CR receiver test channel parameters

Comment #97

Adee Ran, Cisco

CI 179 SC 179.9.5.3 P 366 L 30 # 97

Figure 179A-2—HN-to-HN Channel Max (TP0d-TP5d) at 53.125 GHz

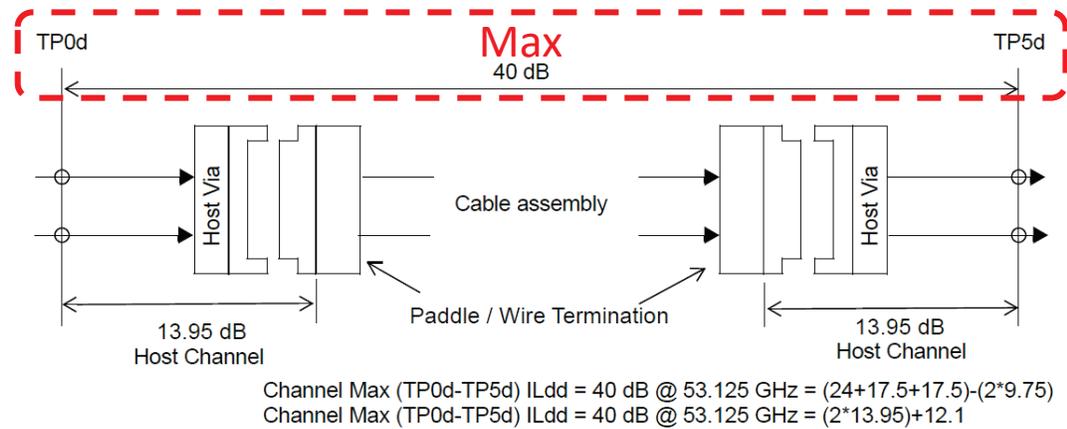
Should be 18.95

Figure 110-3a—Interference tolerance test setup

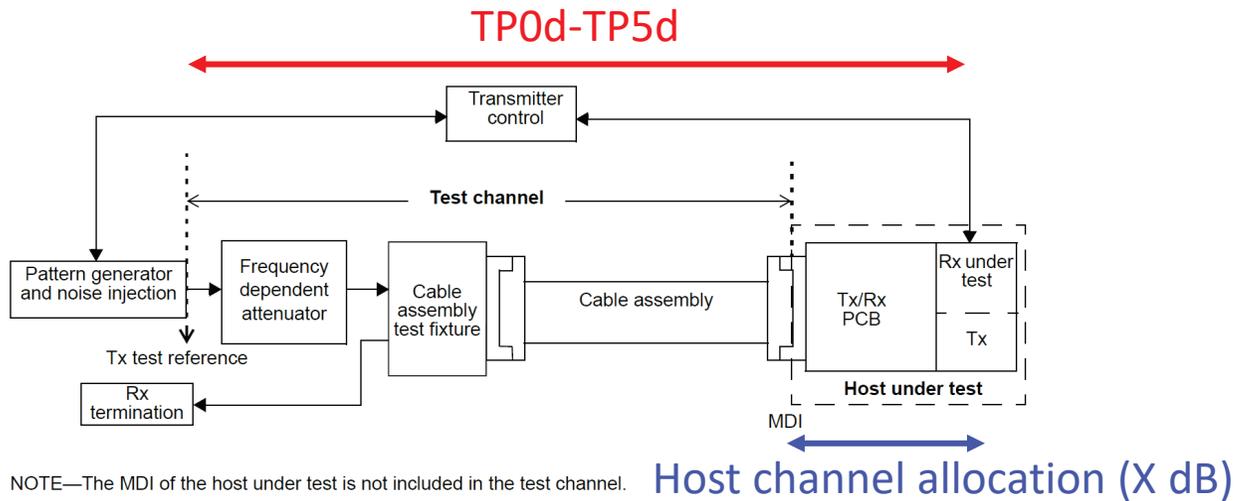
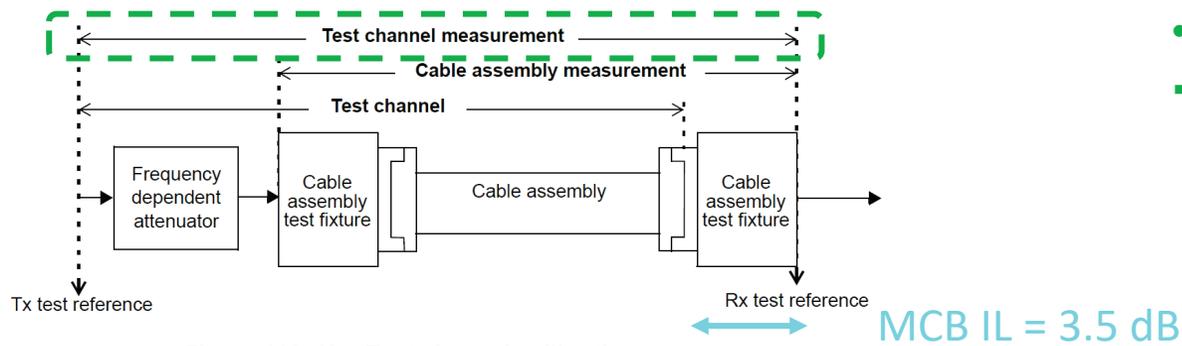
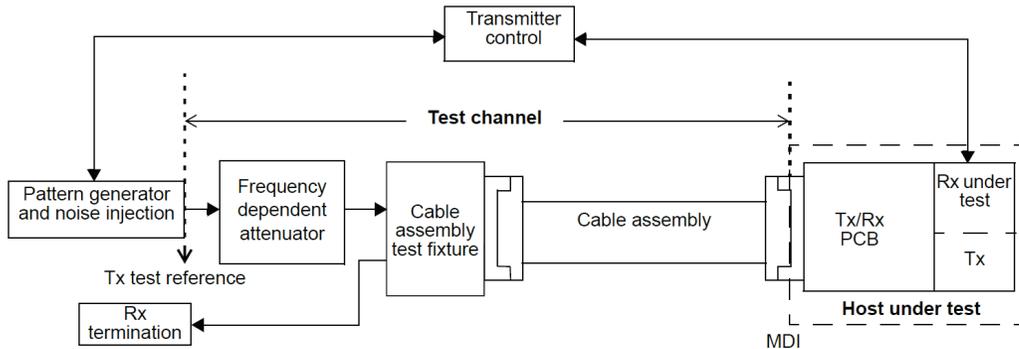
For Test 2 (high loss):

- Max TP0d-TP5d = 40 dB
 - Remove DUT host channel allocation = X dB
 - Add MCB (Rx side) = 3.5 dB
- ➔ Test channel measurement = $40 - X + 3.5$ dB
(HH: 24.55, HN: 29.55, HL: 34.55)

For Test 1 (low loss):

- Test channel = Min CA (including 2 MCBs, no FDA)
- ➔ Test channel measurement = 16 dB

± 0.5 dB

Figure 110-3b—Test channel calibration

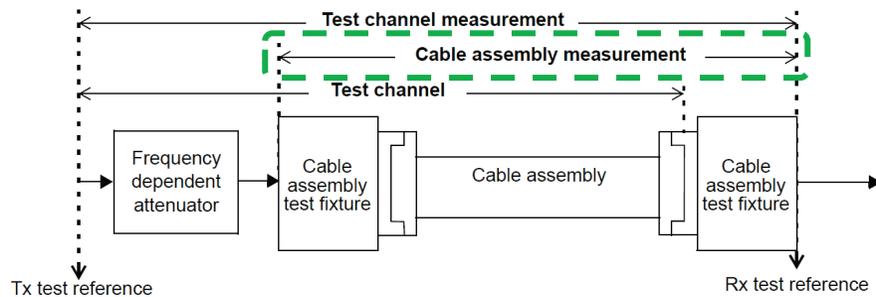
The minimum cable assembly loss is 16 dB for all host classes.
The maximum supported cable assembly is based on host class:

- HH: up to CA-B (24 dB)
 - HN: up to CA-C (29 dB)
 - HL: up to CA-D (34 dB)
- ± 0.5 dB
